2018 Mercedes Benz E63S AMG 4MATIC Sed (213.089) V8-4.0L Turbo (177.980)

Vehicle > Technical Service Bulletins

REAR BUMPER CONTACTS BOTTOM OF TAILAMP

Topic number	LI88.20-P-071479
Version	1
Function group	88.20 Bumpers
Date	07-20-2020
Validity	W and V 213 with series (Not AMG) production bumper
Reason for change

Bild 2

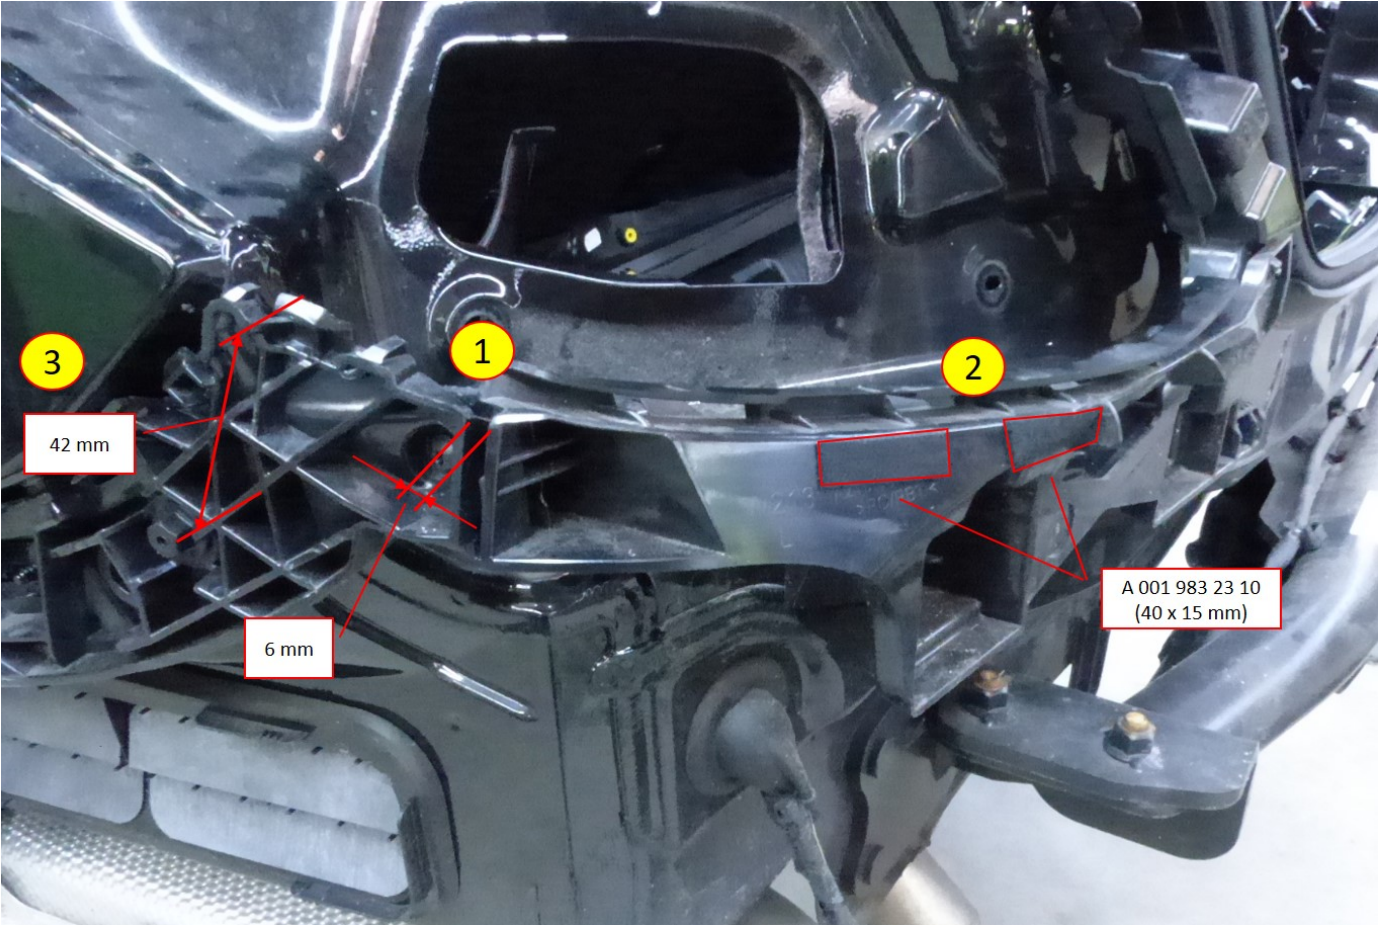
1. Remove the rear bumper and the left and right rear lamps.
2. Adjust the gap between the lateral support and the basic carrier of the rear lamp to 6 mm (see picture 2, measure 1). To do so, loosen the screw at the side, adjust the gap and tighten the screw again.

3. Cut 4 felt strips each measuring 40 x 15 mm from the roll with SN A0019832310 and bond 2 felt strips on each basic carrier under the rear lamps (see picture 2, measure 2; for position of felt strips, see picture 3). The felt strips must be bonded precisely up to the upper edge of the holder under the rear lamp and must NOT protrude.

4. Heat the catch hooks of the lateral support rail locally, e.g. using a cigarette lighter or heat gun (see picture 4) and carefully widen to a distance of 42mm (see picture 2, measure 3). When doing so, use a vernier caliper and measure between the cross in the lateral support and the top edge of the catch hook.

1. Adjust gap of lateral support to 6 mm
2. Bond on felt strips. For position of felt strips, see picture 3
3. Bend open catch hook to 42 mm by applying heat locally
- Position of felt strips
- Heating locally before bending open (e.g. using cigarette lighter)
